Product Change Notification (PCN)

PCN #: 10C-2021

Laird Part Number	Description
453-00045R	Module, Sterling LWB5+, Chip Antenna, Tape & Reel
453-00046R	Module, Sterling LWB5+, MHF4, Tape & Reel
453-00047R	Module, Sterling LWB5+, Trace Pin, Tape & Reel
453-00048	Module, Sterling LWB5+, M.2, Key E, SDIO, UART
453-00049	Module, Sterling LWB5+, M.2, Key E, USB, USB

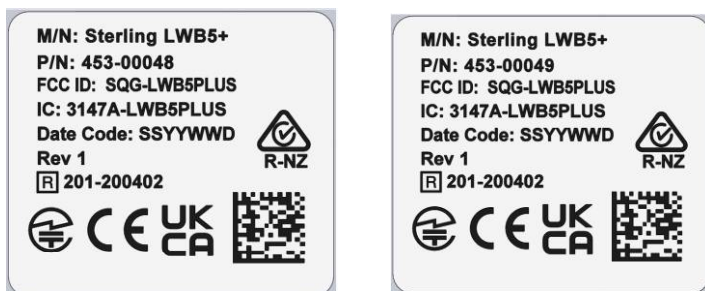
- Added UKCA certification logo to shipping reel, bag and box label and update pictogram to UKNI
- Added UKCA certification logo to shipping carton label and update pictogram to UKNI

- To ensure compliance with latest UKCA certification standards
